**From:** [Dan Grove](#)  
**To:** [Molly McGuire](#)  
**Subject:** Existing Grade for permit 2207-019 SUB3  
**Date:** Friday, June 9, 2023 9:00:14 AM  
**Attachments:** [2207-019 Existing Grade - for SUB3.pdf](#)

I'd like to submit this document to provide enhanced information on the Existing Grade of permit 2207-019 SUB3.

Molly McGuire  
Mercer Island Community Planning and Development Department  
RE: Permit 2207-019 SUB3 / 6950 SE Maker Street  
Jun 9, 2023

Figure 2. 1955 King County Assessor photo showing same hillside as 1963 Aerial Image in Figure 3b

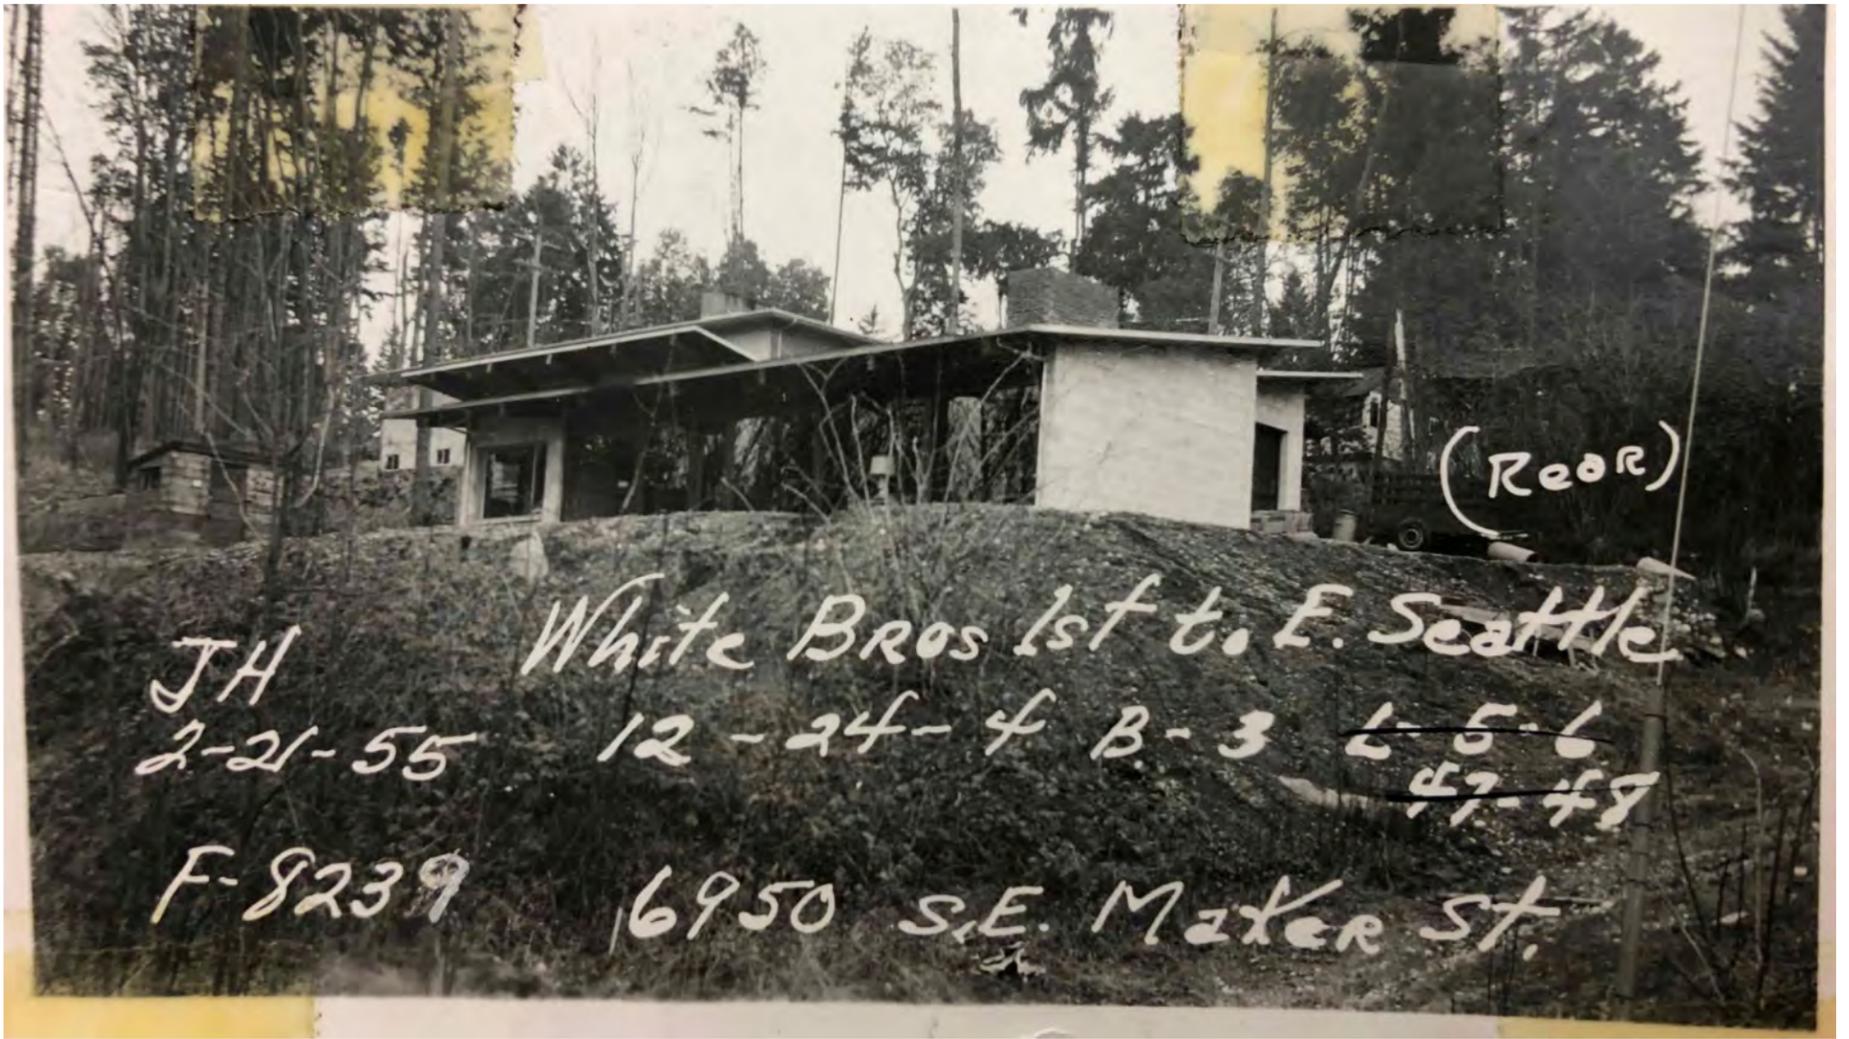
Figure 2 shows a photo of the Lot in 1955, after its initial Alteration.

When this photo was taken, the area directly in front of the house had approximately 10' of fill in place (based on the 1963 Survey and 2022 Geotechnical Survey, shown below). When this photo was taken, the grade of the site had already been significantly Altered from the Existing Grade by installing fill.

This fill installation is the first of at least 2 major fill installations that occurred on the site over its lifetime.

Figure 3. Survey showing original grade of SE Maker Street, 1963. The grade shown for 6950 is already Altered from the Existing Grade. ("1963 Survey")

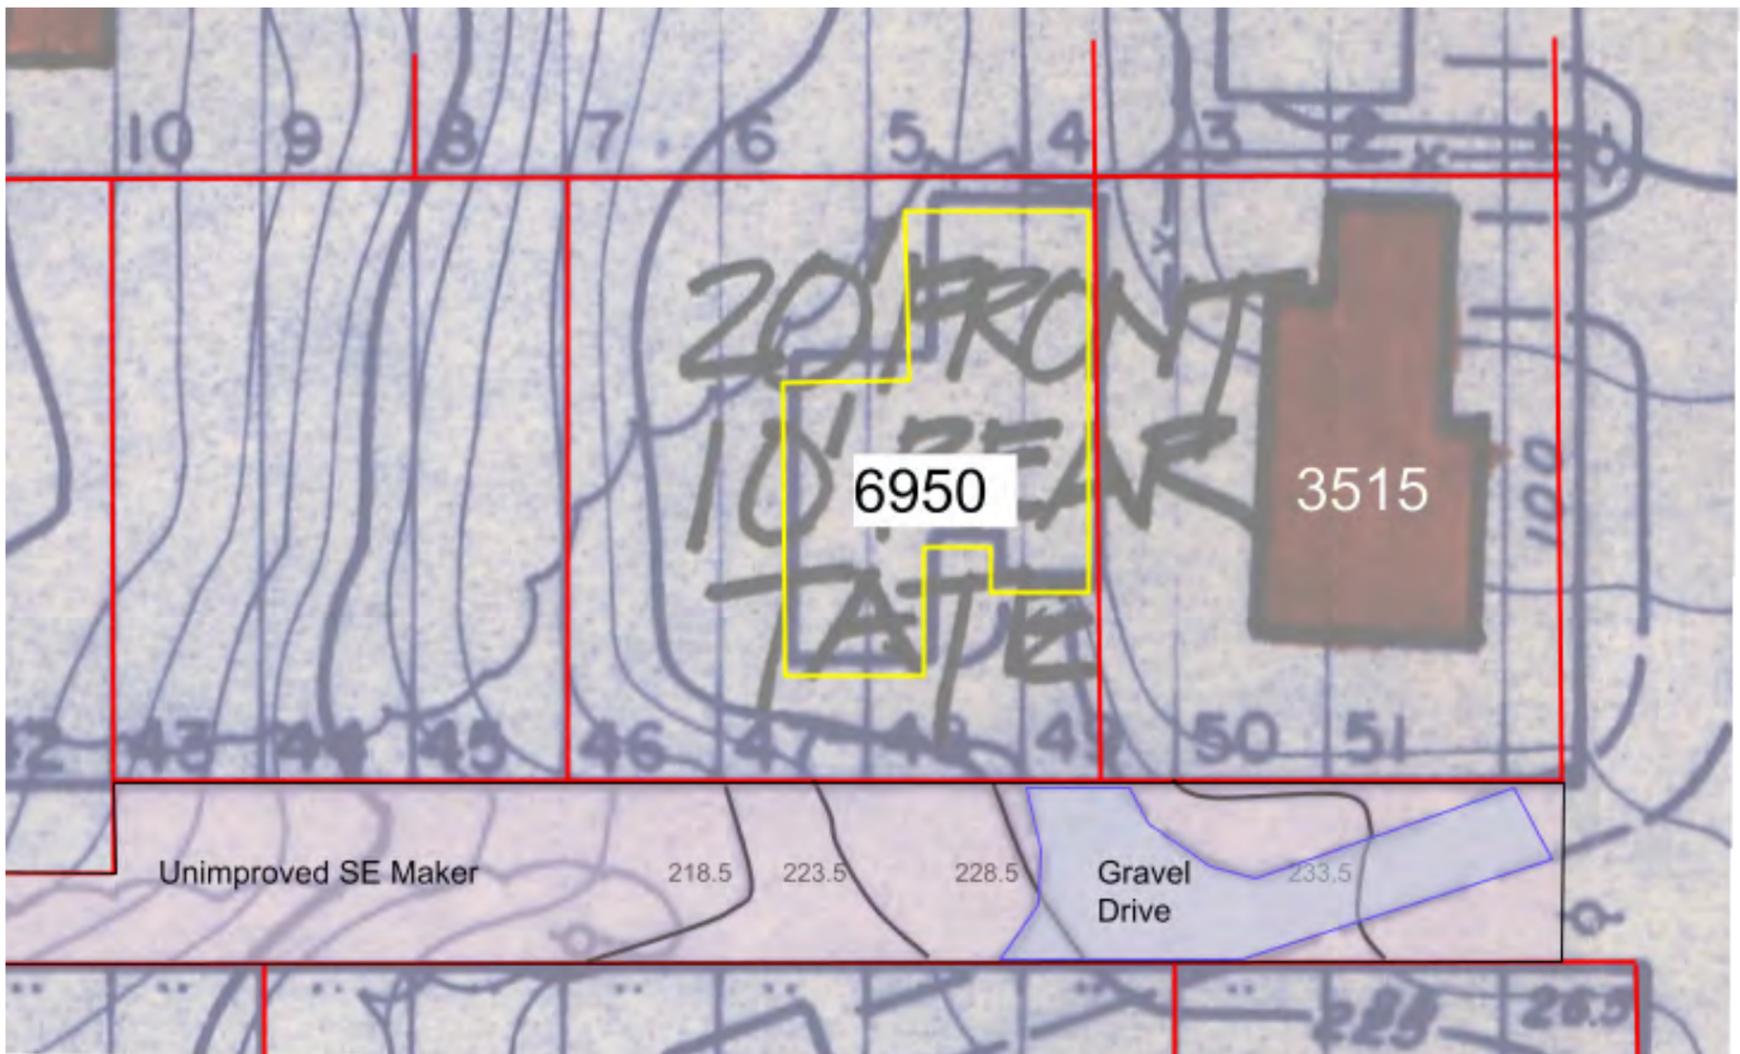
Figure 3 is taken from a [Mercer Island 1963 survey](#) that shows the contours of the Lot and the SE Maker right-of-way after the 6950 house was completed in 1955, but before the rockery was put in place around 6950.

At this time, SE Maker consisted of a gravel driveway on its west end (towards 72nd Ave SE). The rest of SE Maker was still unimproved in 1963.

Figure 4. Existing Grade of from 1989 survey of 7145, immediately north of 6950 ("1989 Survey")

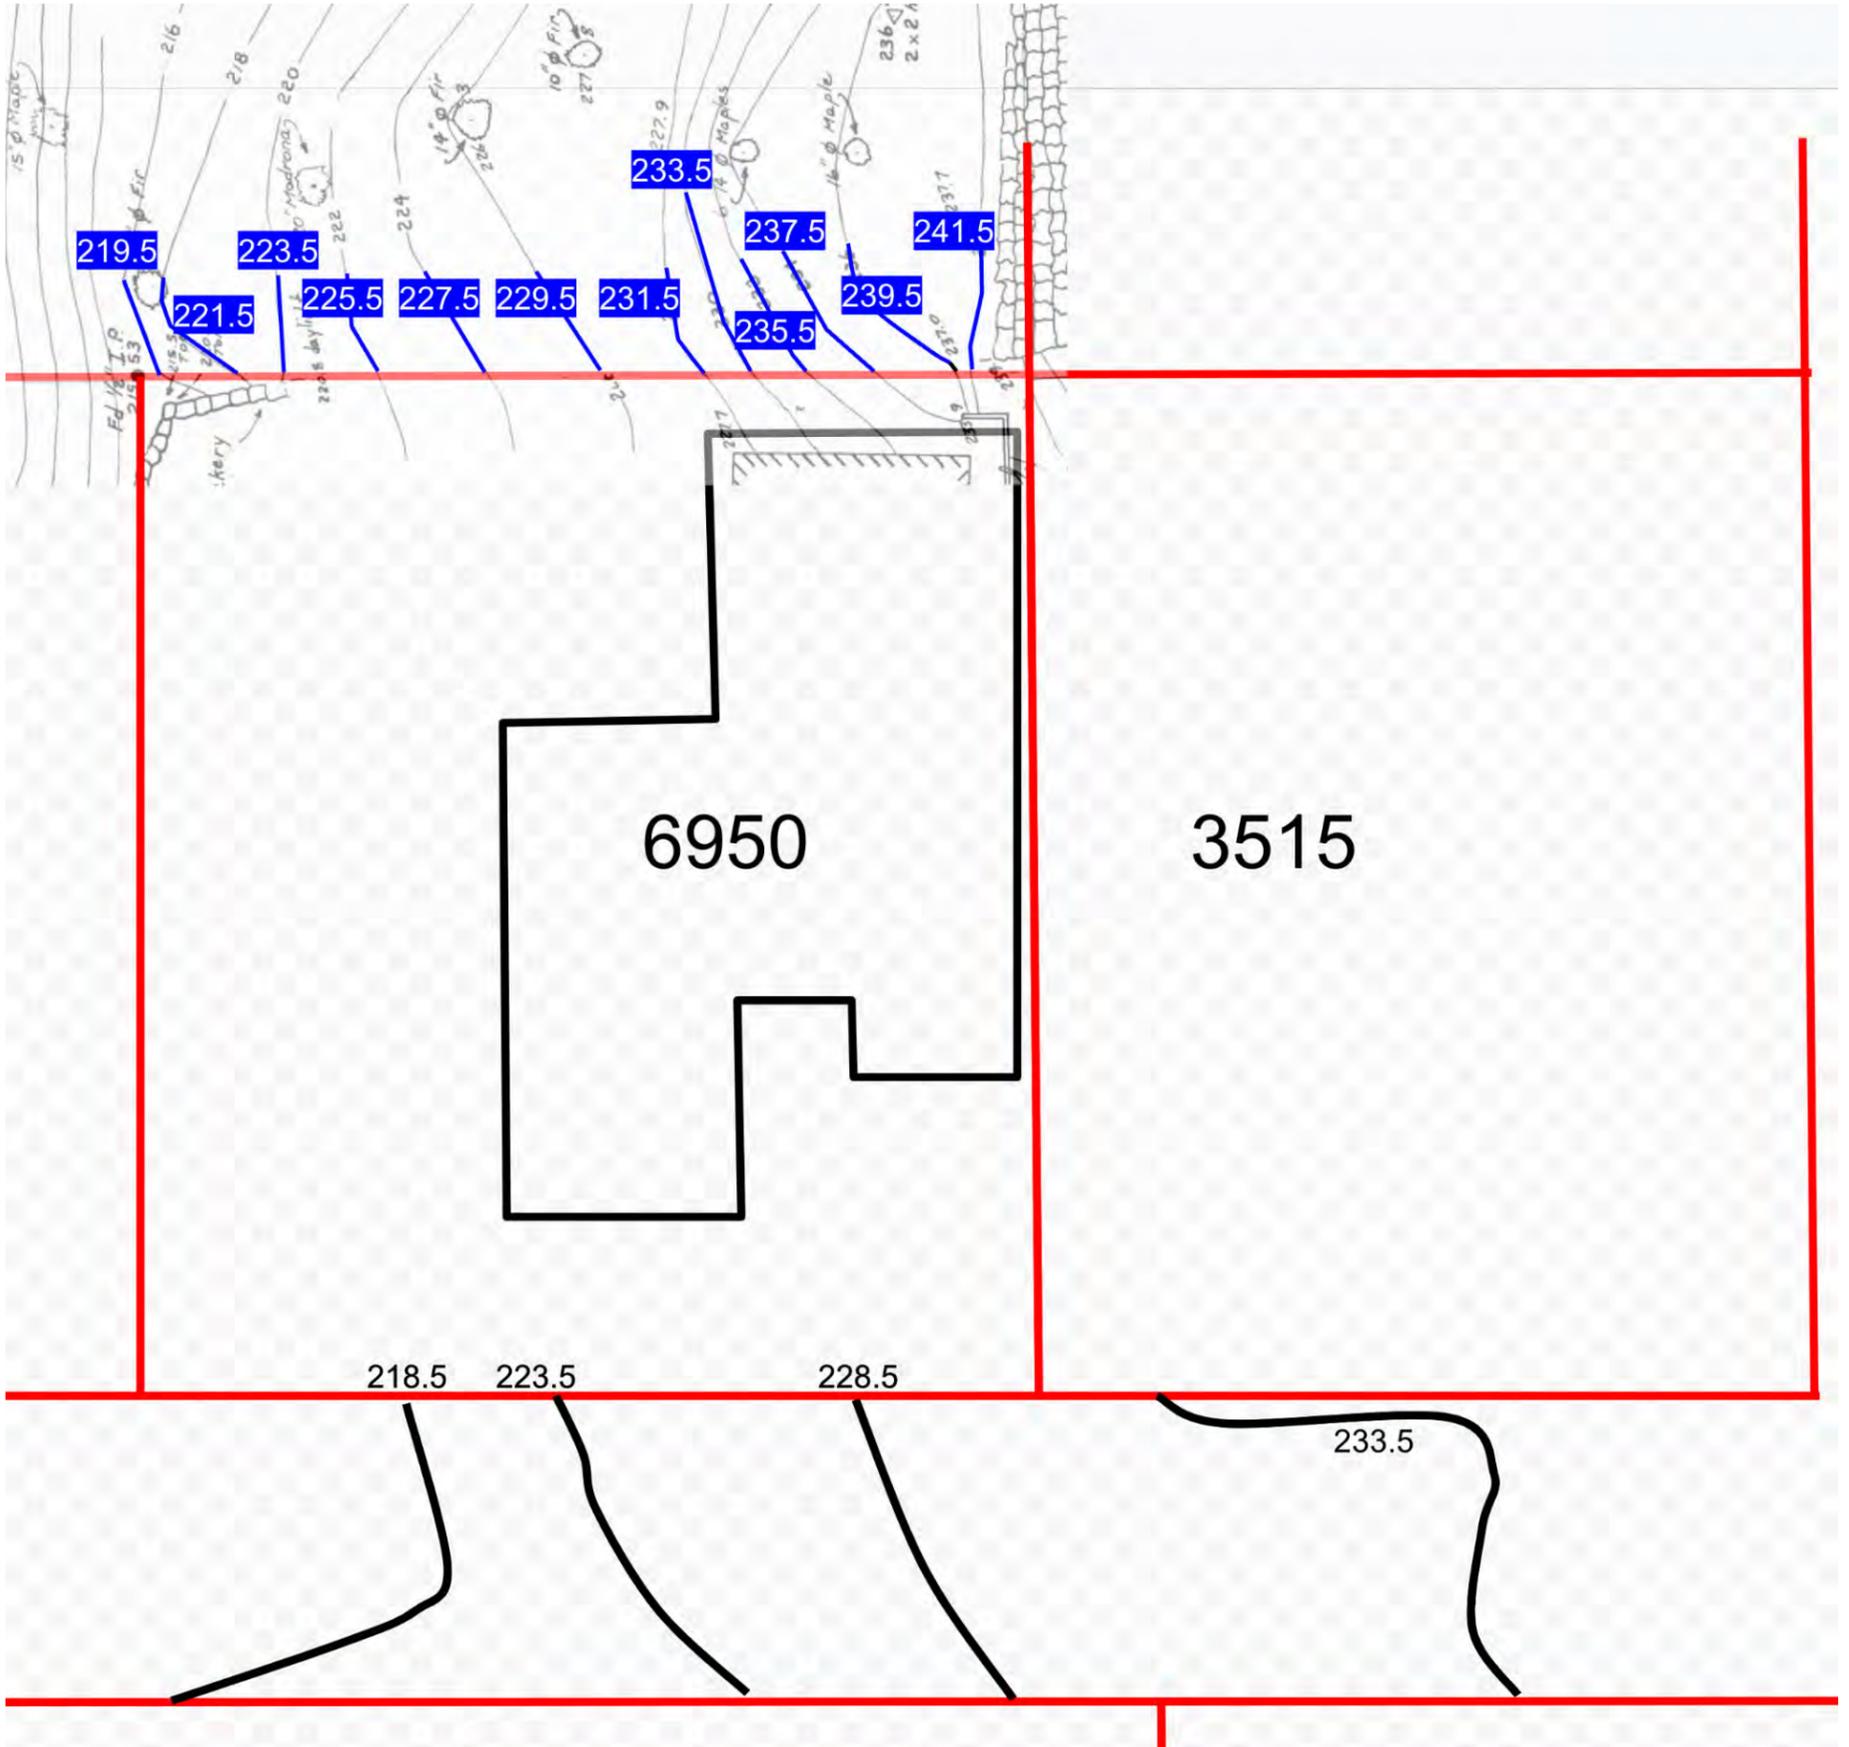
Figure 4 shows (in blue) the contours of Existing Grade of 7145 SE 35th Street, immediately north of 6950, as established in the 1989 Survey. This is prior to Alteration of 7145, as is shown by the large trees in the 1989 Survey and 1989 Geotechnical Survey of 7145 SE 35th. Between the 1963 Survey and this 1989 Survey, we have clear Existing Grades for both the North and South boundary lines of 6950.

Note: the east-west portion of the 233.5 line is due to Alteration prior to any survey - the rockery on the south side of 3515 existed prior to the 1963 survey.

Figure 5. Interpolation of contours between the Existing Grade of SE Maker and the Existing Grade of 7145 SE 35 Street  
Black Dashed Line: Interpolated between 1963 Survey (south side) and 1989 Survey (north side)

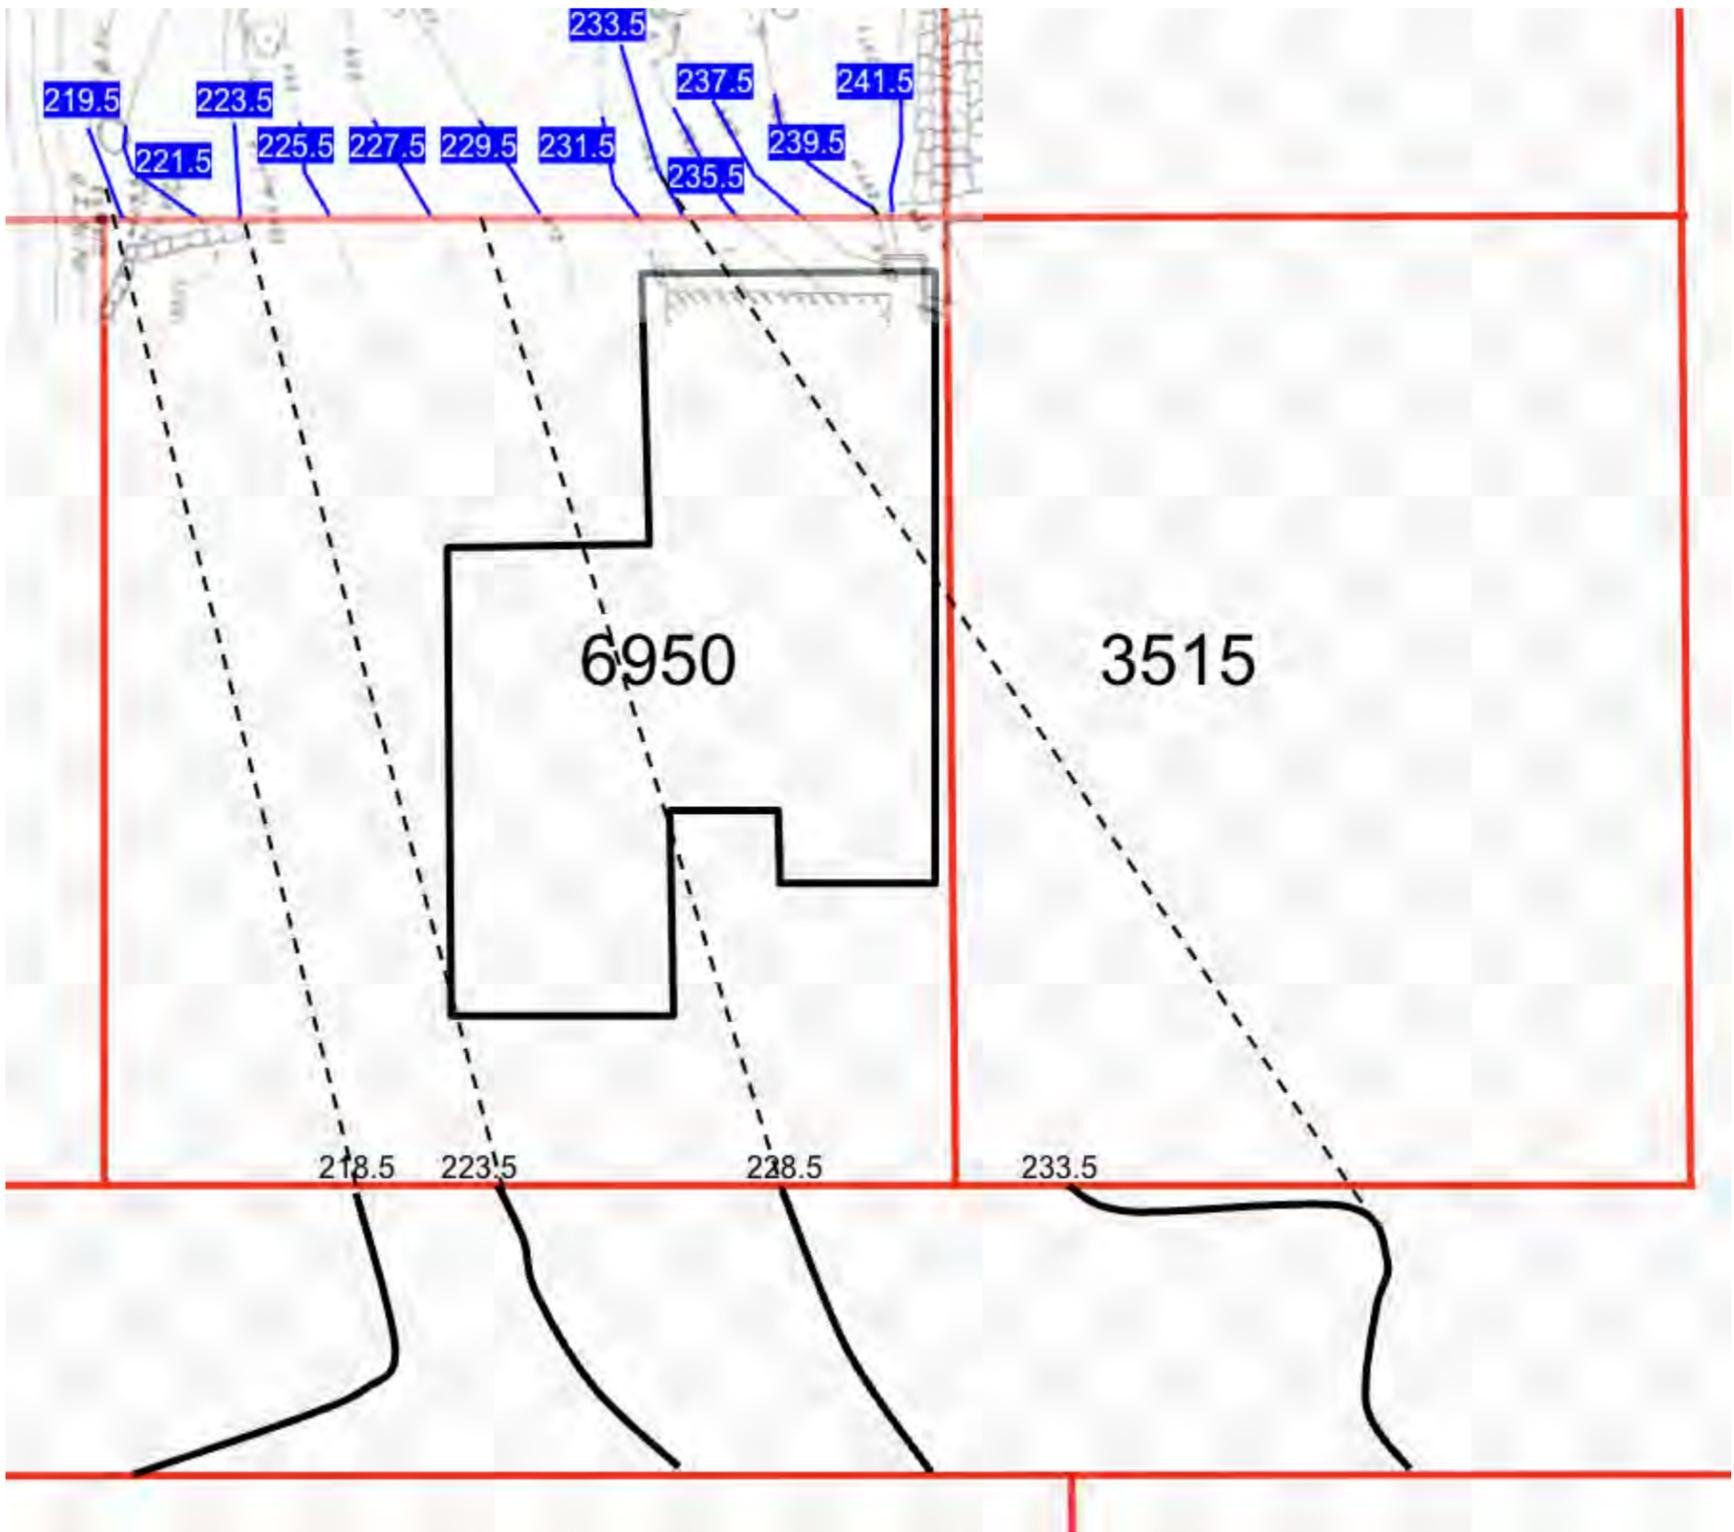
With knowledge of the Existing Grade immediately north and south of 6950, we can interpolate contour lines (shown as Dashed Black Lines), shown in Figure 5.
